Nuclear Products  
21 December 1965

Thank you for your letter of 6 December 1965. We will be very happy to manufacture an experimental self-luminous source in line with your drawing B-11006314. This source will be fabricated from lucite and the luminous material ( $Pm^{147}$ ) will be sealed in the holes by means of an epoxy sealant. This method of construction is basically identical to our LC2 series source which is on file with the AEC. We will not be able to provide you with brightness as high as those indicated in your letter. I would like to suggest the following alternate arrangement with the number of millicurie of  $Pm^{147}$  required:

Sketch # 1

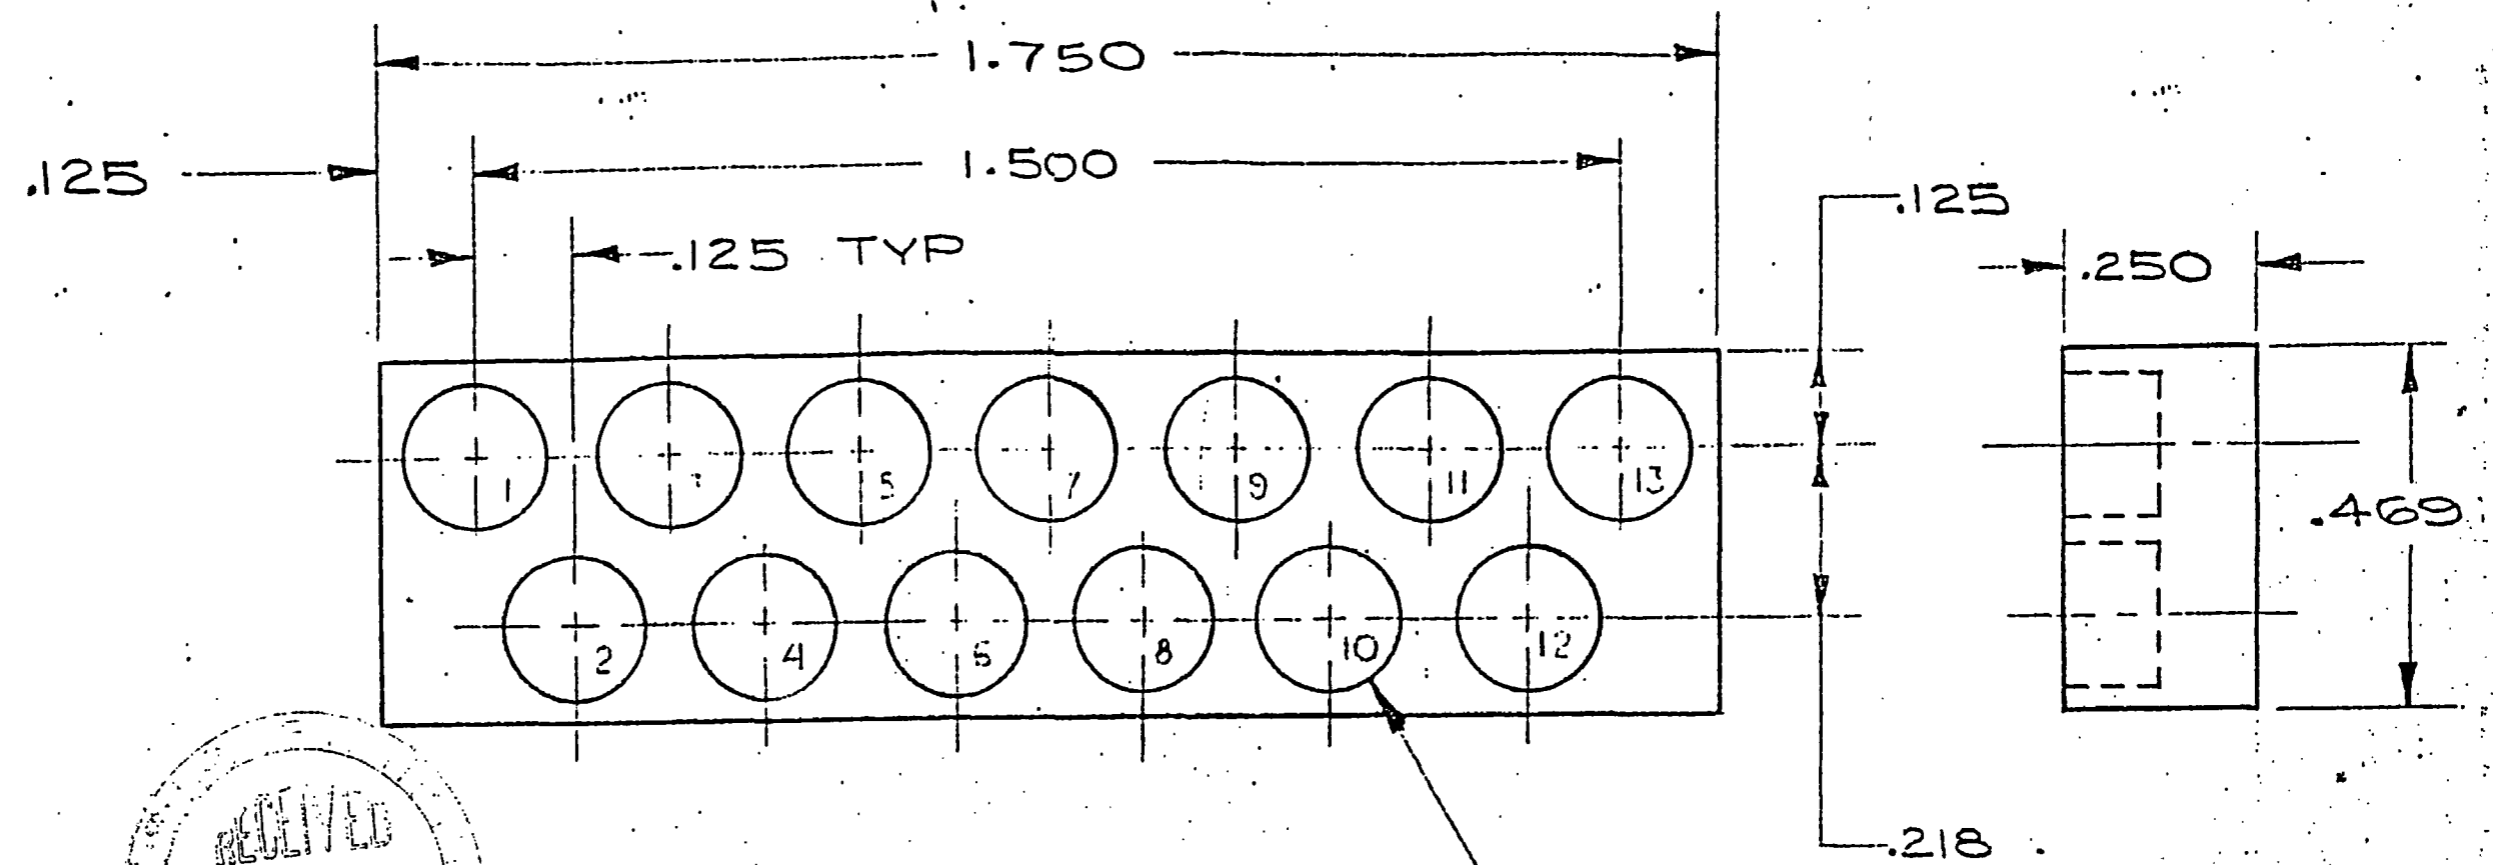
<u>Hole Number</u>	<u>Microlamberts</u>	<u>mc <math>Pm^{147}</math></u>
1	200	6
2	200	6
3	500	17
4	500	17
5	750	27
6	750	27
7	750	27
8	1000	37
9	1000	37
10	1000	37
11	1500	63
12	1500	63
13	1500	63

This is a total of about 427 millicuries of  $Pm^{147}$  divided up among the 13 spots. Each of these spots comprises an individual sealed source. The spots will be numbered and the brightness of each spot will be determined and provided to you. We will not be able to guarantee any brightness levels before construction but will provide this to you on a best effort basis and will advise you as to the brightness of each individual spot.
